TANK CLOSURE AND WASTE MANAGEMENT ENVIRONMENTAL IMPACT STATEMENT

U. S. DEPARTMENT OF ENERGY
TC & WM EIS
Comment Form
Formulario para comentarios

Figure N-155. Fluxes of Iodine-129 at the Water Table for Two Waste Forms for the 70 Percent Partition to Immobilized Low-Activity Waste Glass Case

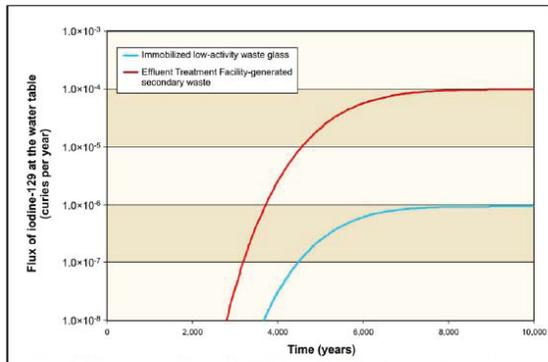
projected to exceed benchmark concentrations. As such, reasonable mitigation measures could be considered that would recycle secondary waste streams into the primary waste stream feeds within the WTP to increase iodine-129 capture in ILAW and bulk vitrification, which are considered more stable waste forms than those associated with secondary waste. The current WTP design supports the ability to recycle. For example, one method would involve the recycling of iodine within the WTP by capturing it in the submerged bed scrubber and returning it to pretreatment. This recycling could theoretically concentrate the iodine in the feed stream, which, in turn, could put more iodine in a specific volume of glass product. Also, the development of more robust, longer-performing waste forms, particularly with regard to cast stone, steam reforming, and grouted secondary waste, could be pursued.²⁹

The current plan to dispose of iodine-129 in a secondary waste stream in the Effluent Treatment Facility (ETF) is clearly unsatisfactory. The TC&WM EIS analysis shows that the annual flux of iodine-129 at the water table is orders of magnitude greater in case of ETF disposal compared to incorporation in ILAW glass that is disposed of on site. The figure below, reproduced from Appendix N of the EIS, shows that iodine-129 contamination of the groundwater would exceed that from ILAW by two orders of magnitude even when the majority of the iodine-129 (70 percent) is incorporated in the ILAW.
